FINAL DRAINAGE REPORT
for
WINDERMERE FILING NO. 1

Colorado Springs, CO

SF-21-026

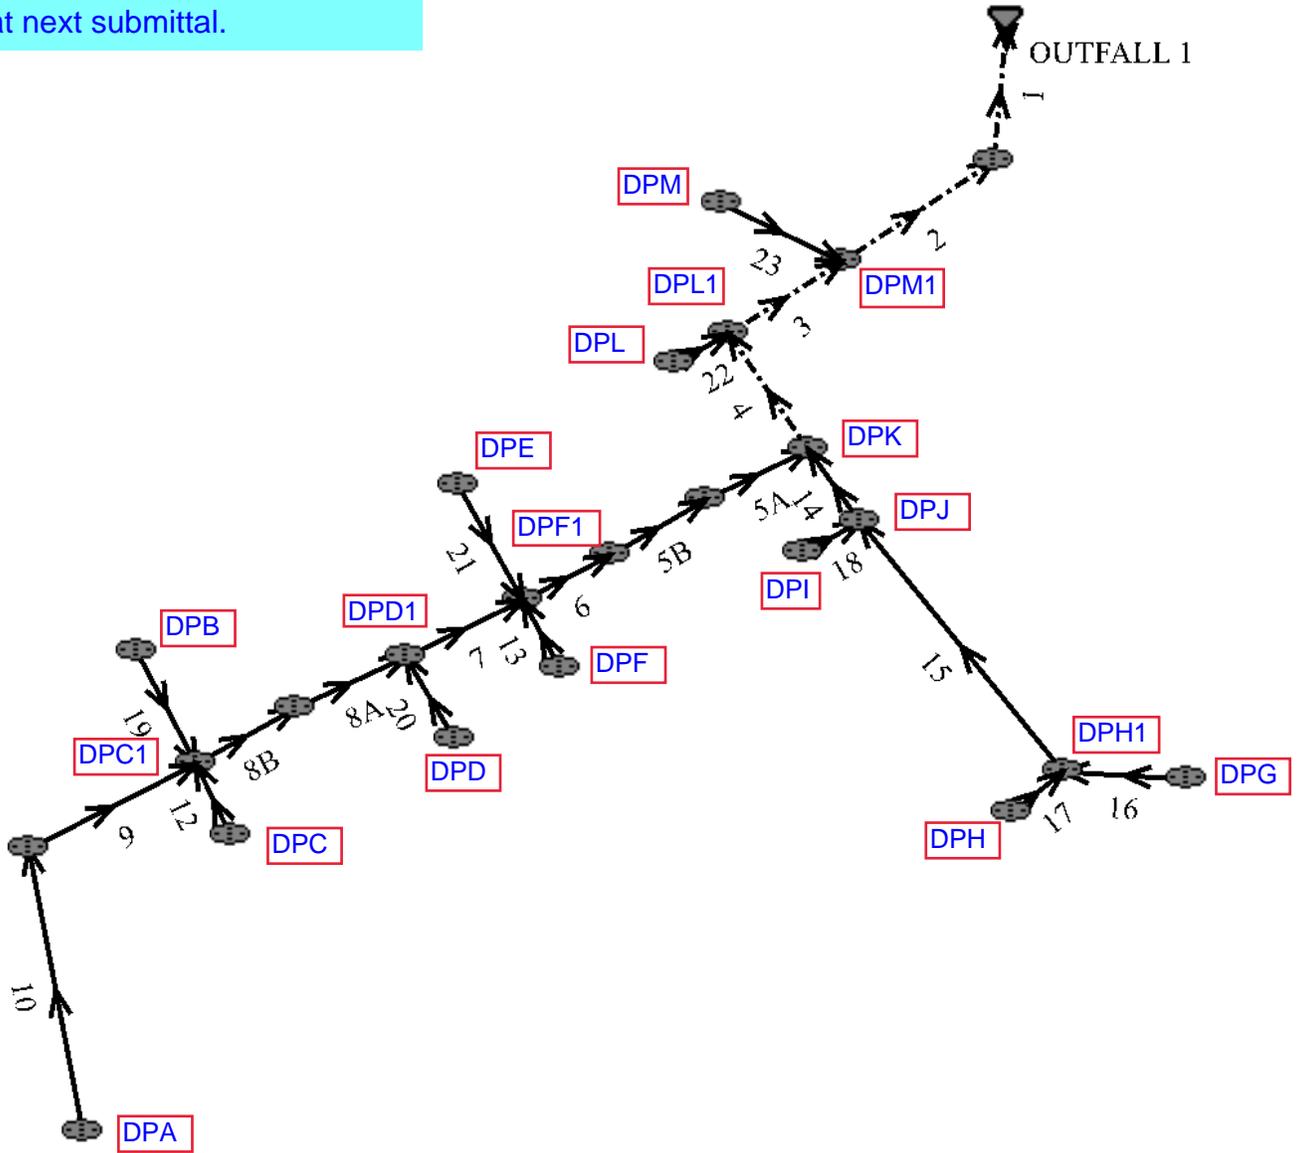
DP Table on
Drainage plan shows
area as 434.39 acres.

Full review not performed on storm system & inlet sizing due to possible changes in flows with edits to "C-values" in hydrology calculations. Review will be completed at next submittal.

DETENTION BASIN STAGE-STORAGE TABLE BUILDER

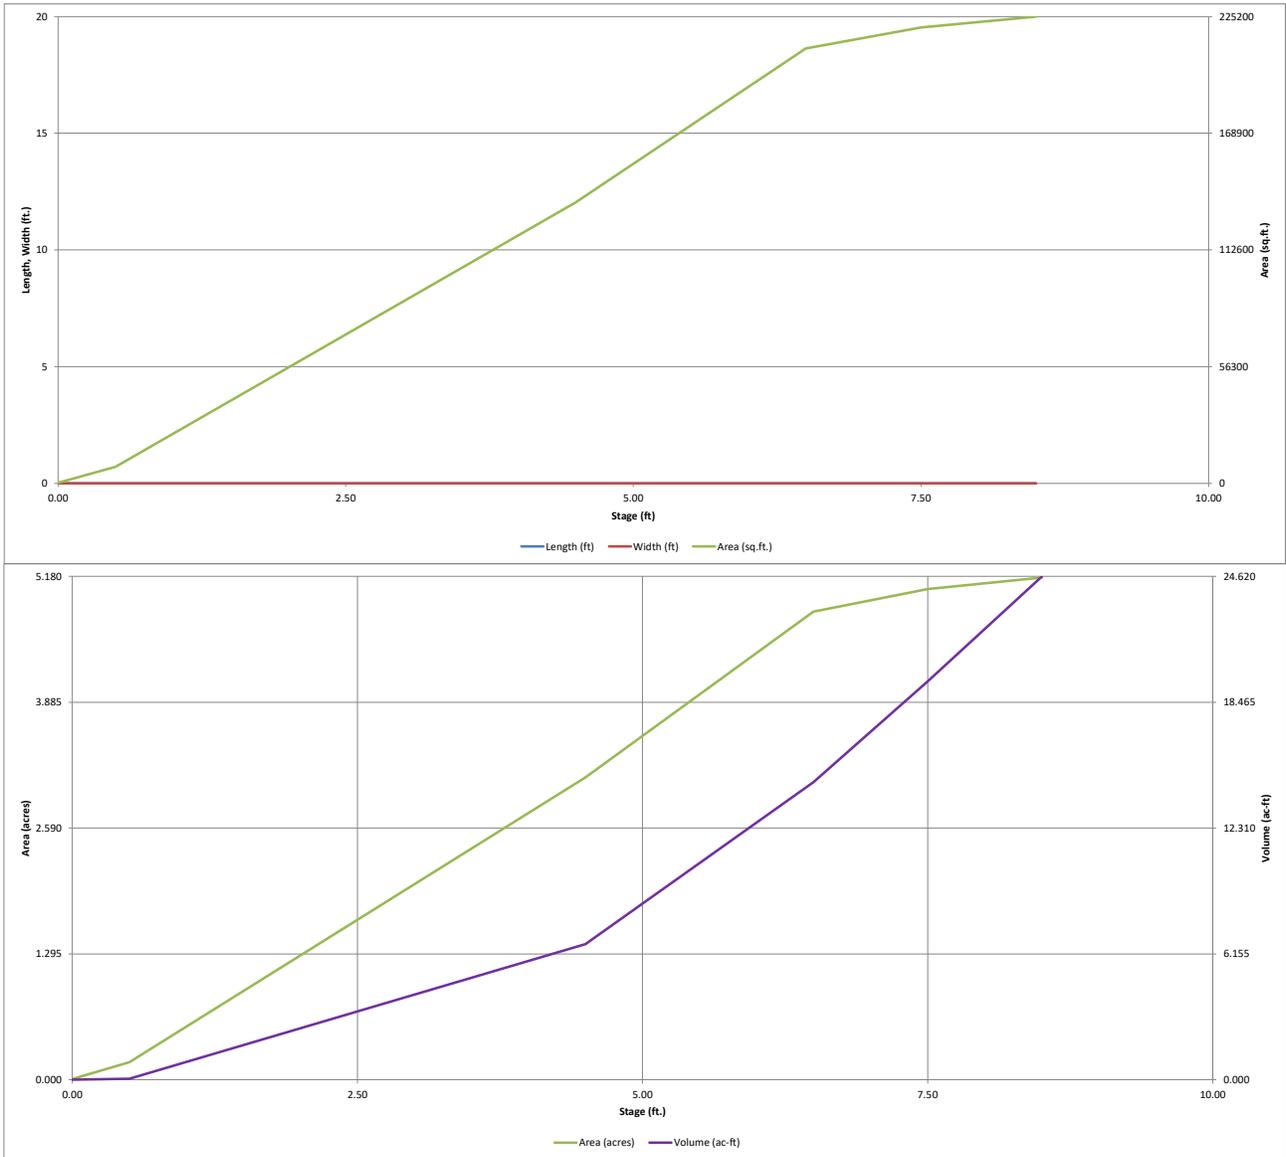
This should be ~1

DR1

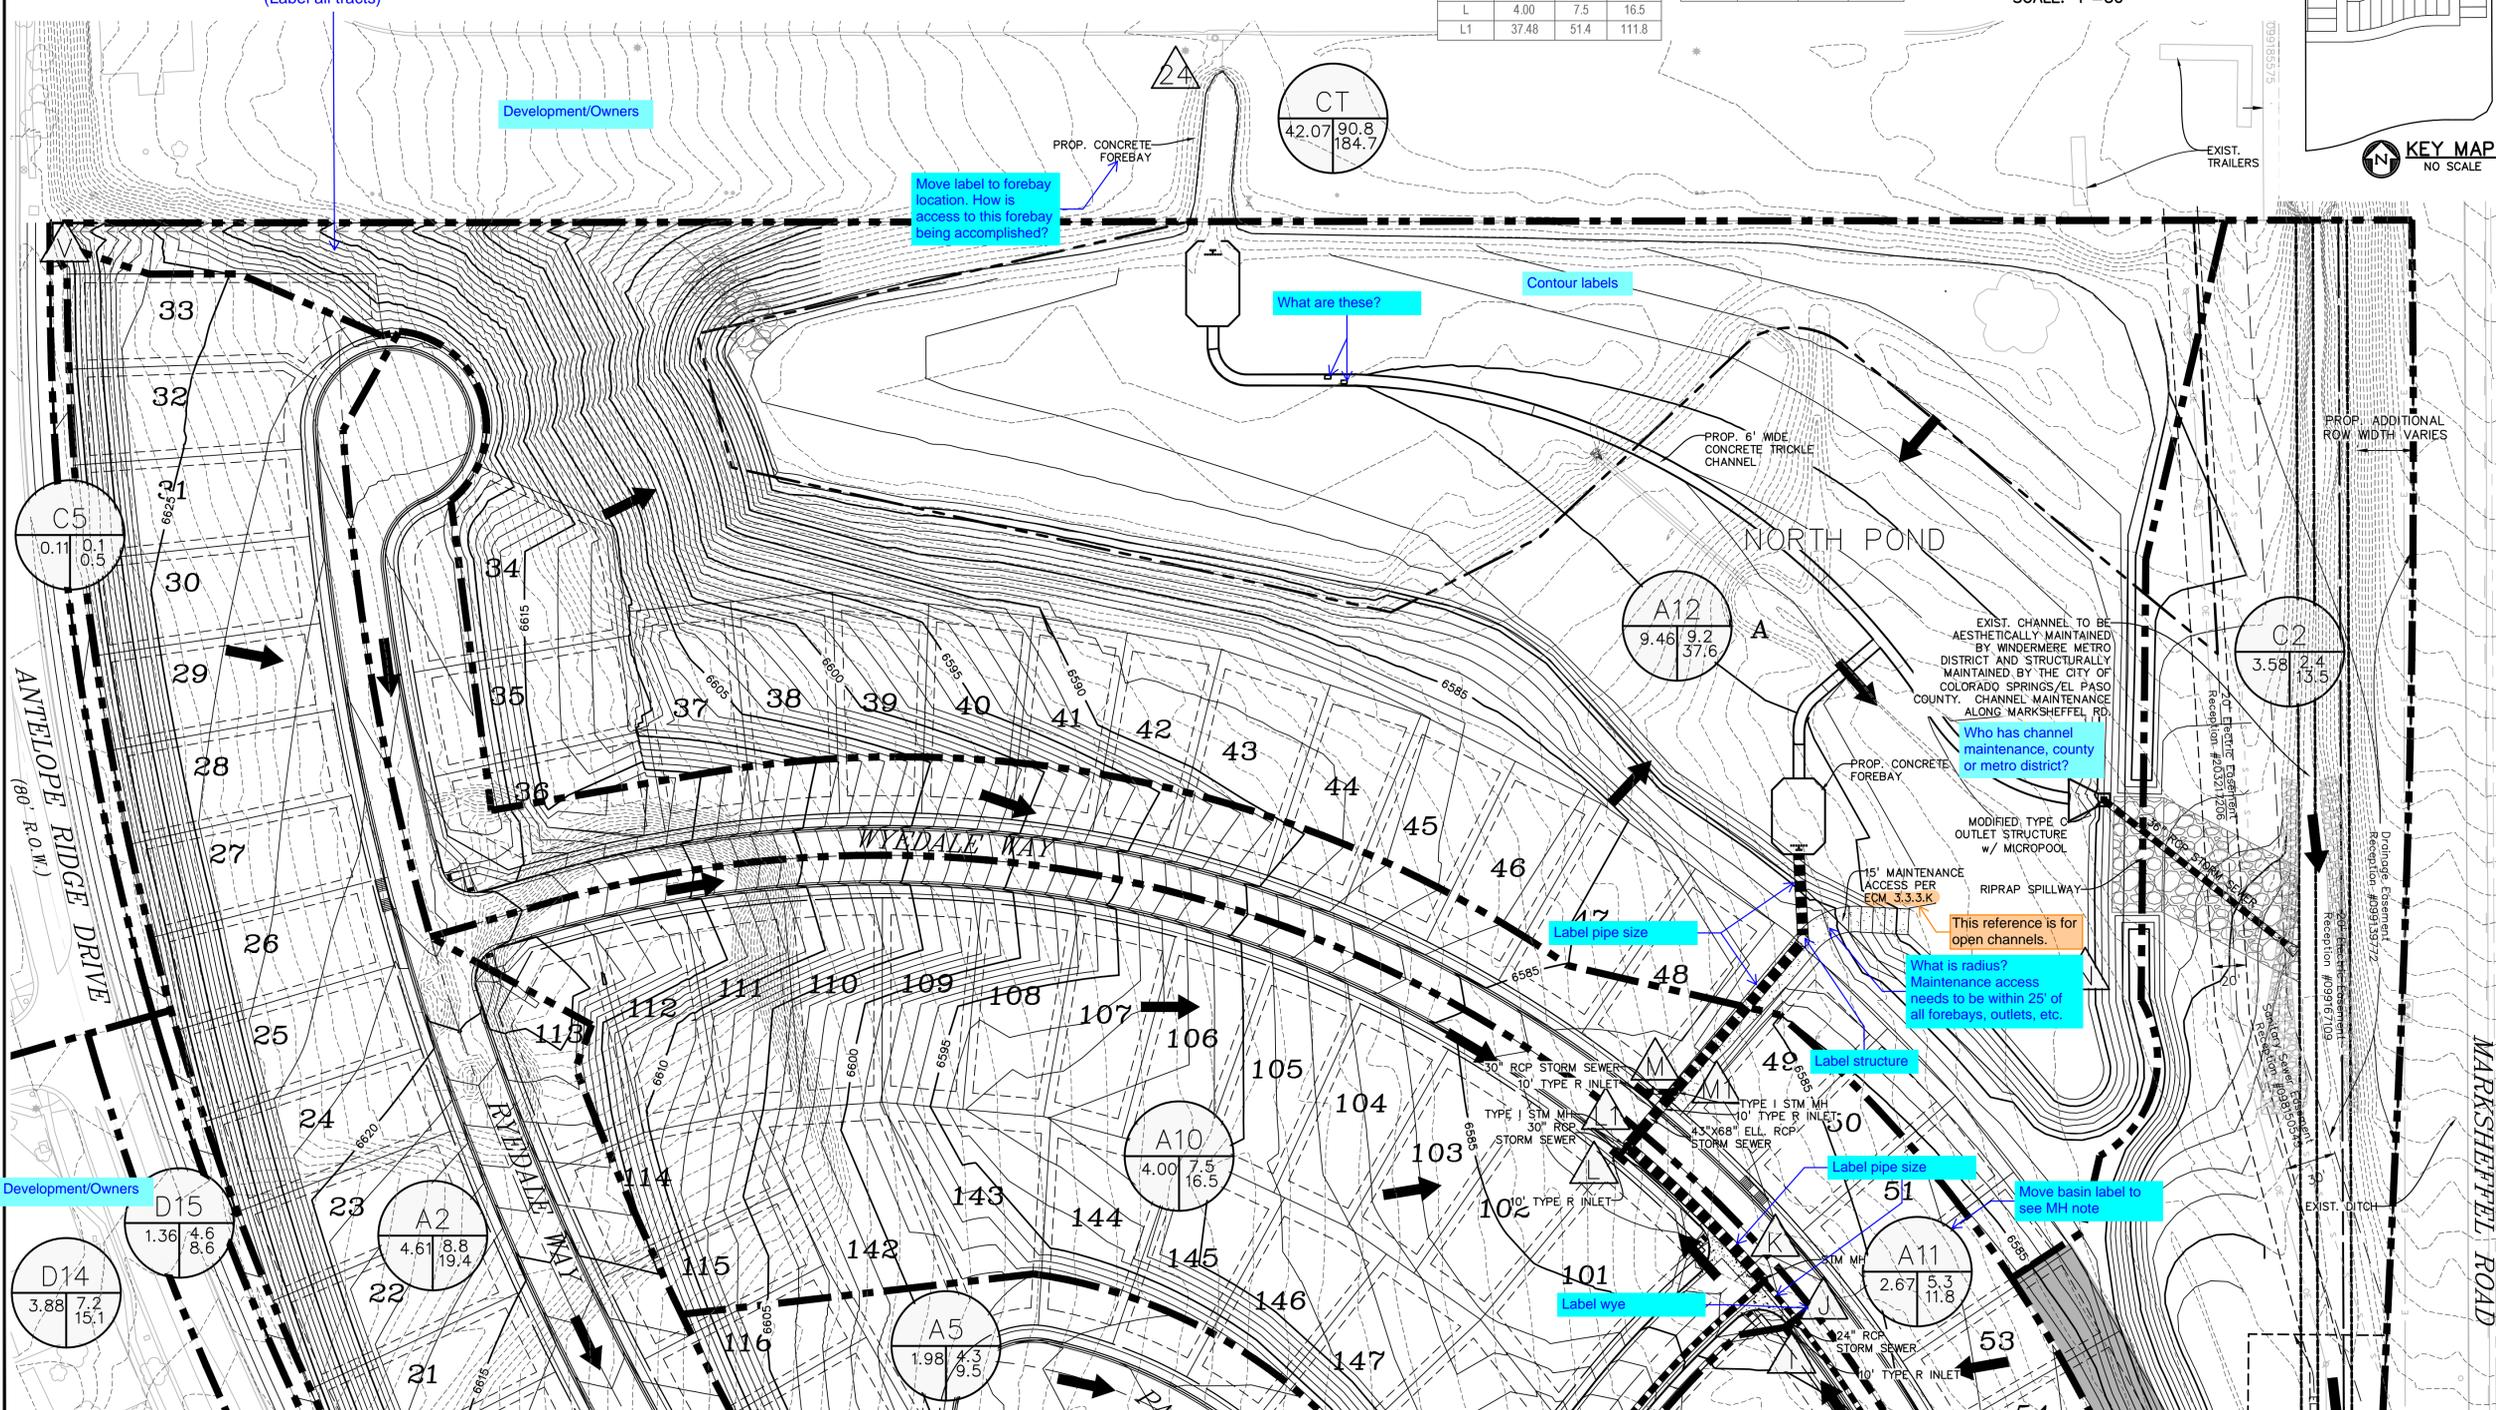
Provide outlet protection riprap calculations

DR4

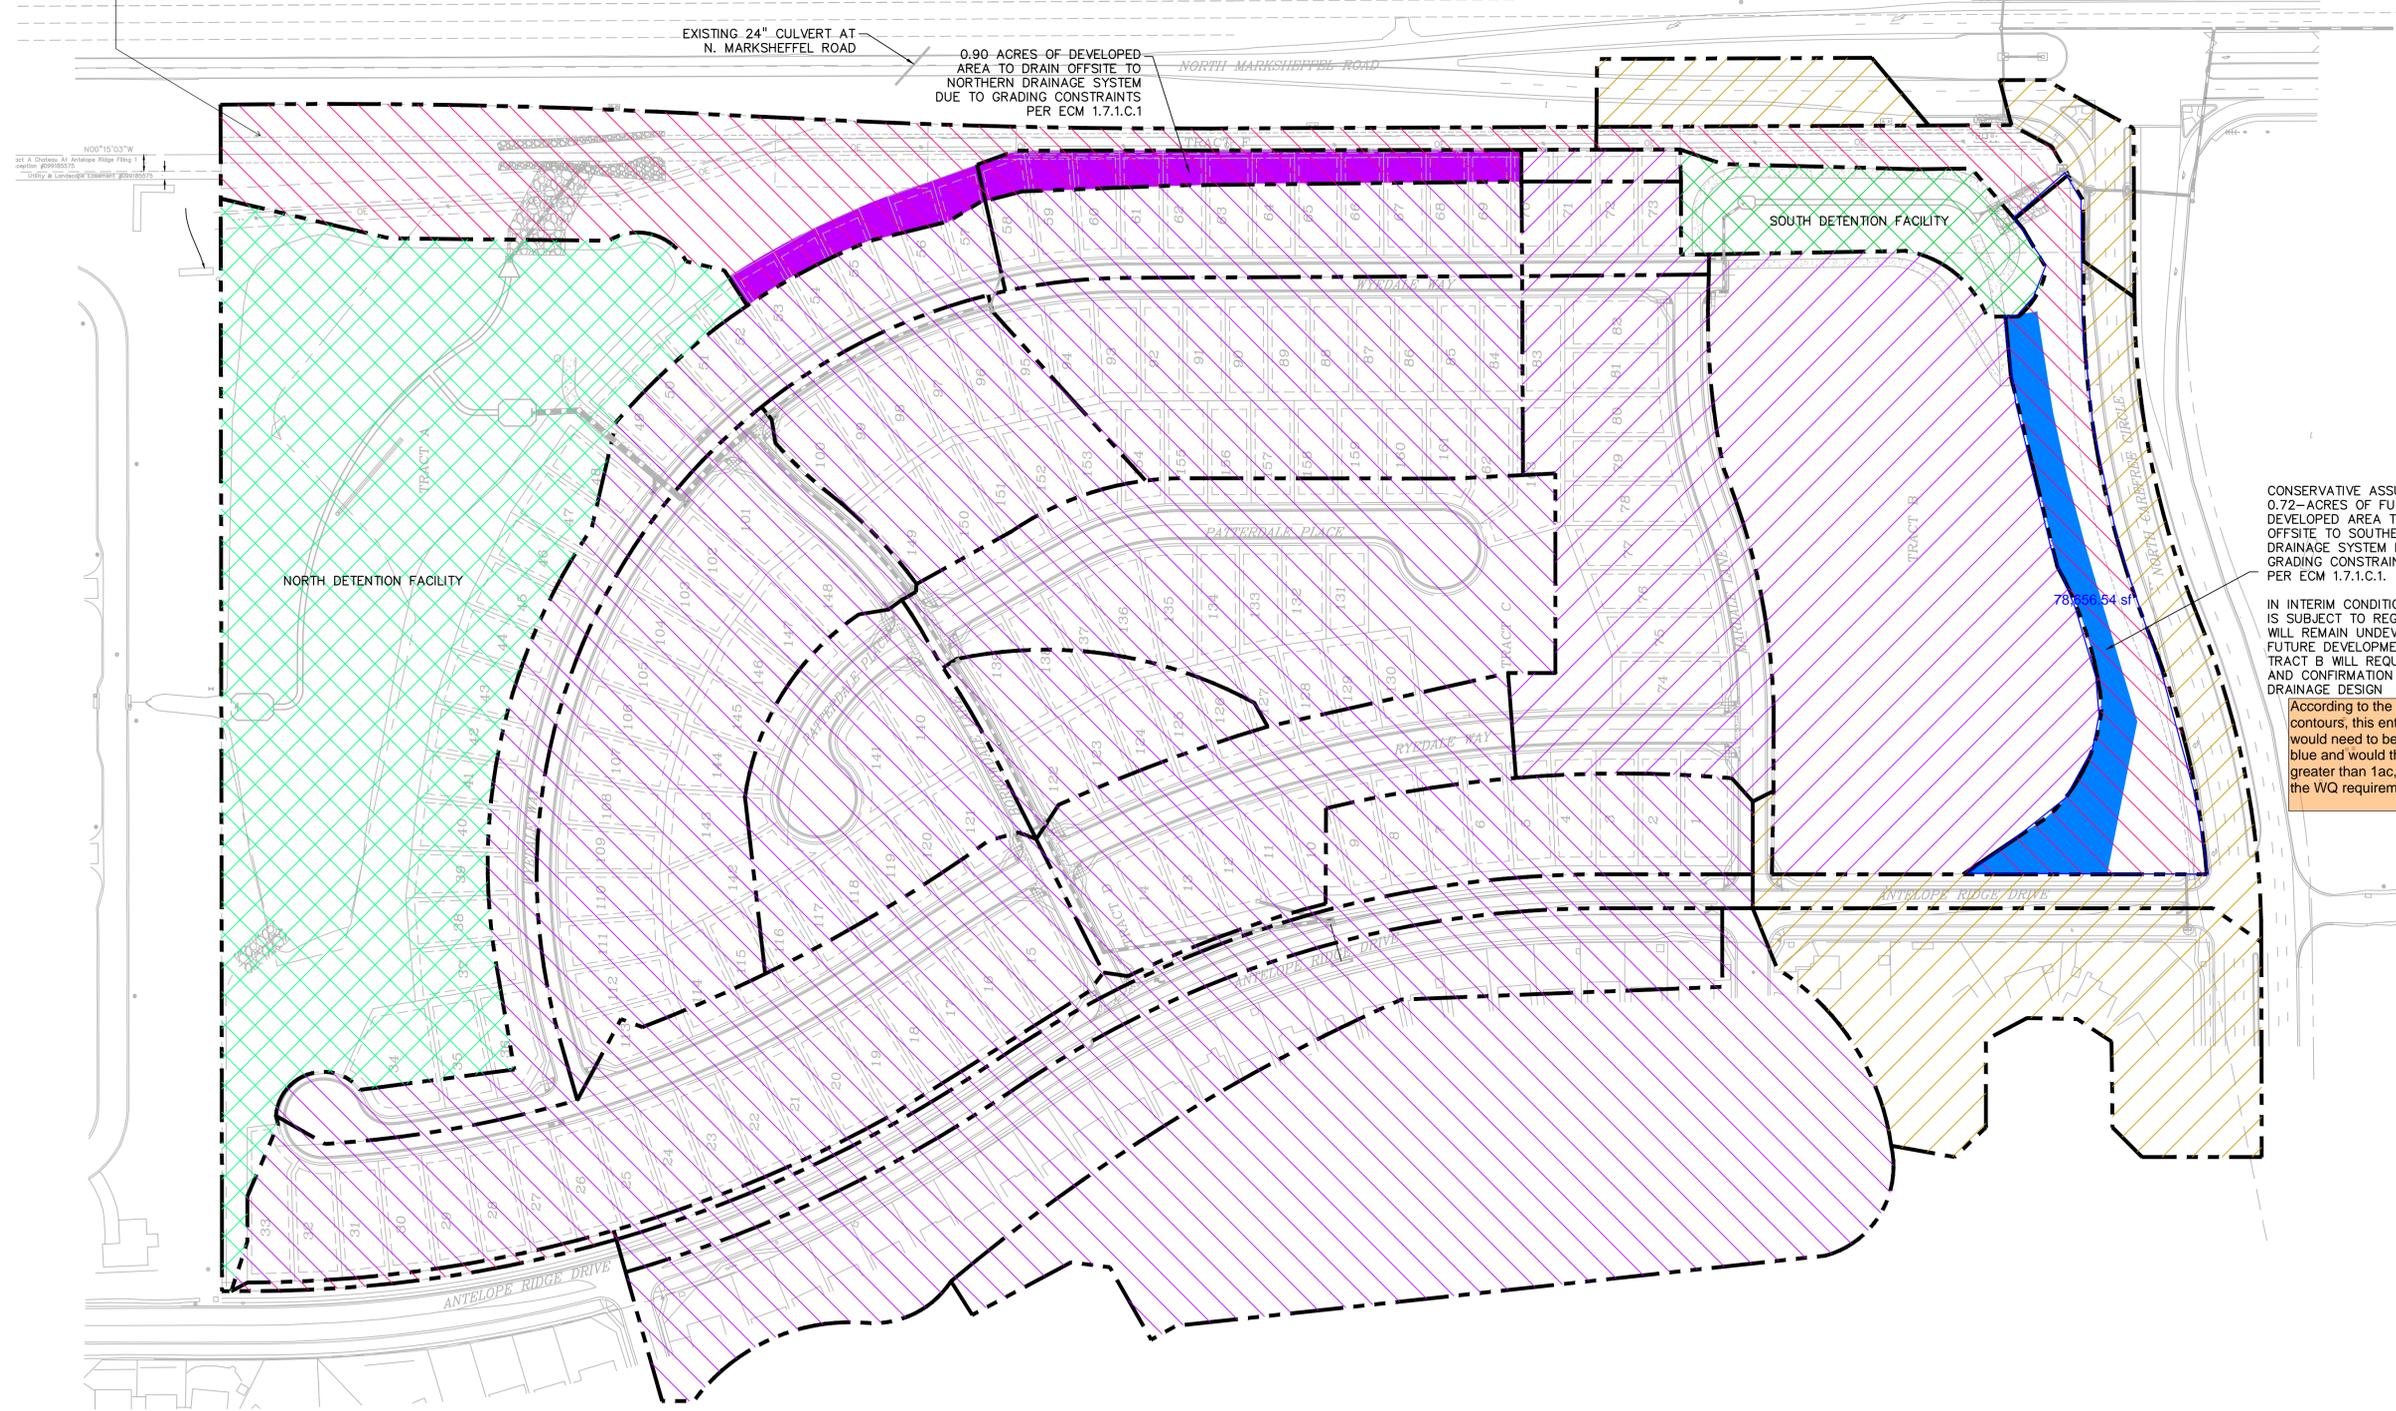
The ECM allows for 20% of the site, up to 1 ac of the applicable development site area to not be captured. these two areas add up to over 1 acre. WQ will be required for areas over the 1 acre limit.

Should be 1"=100'?
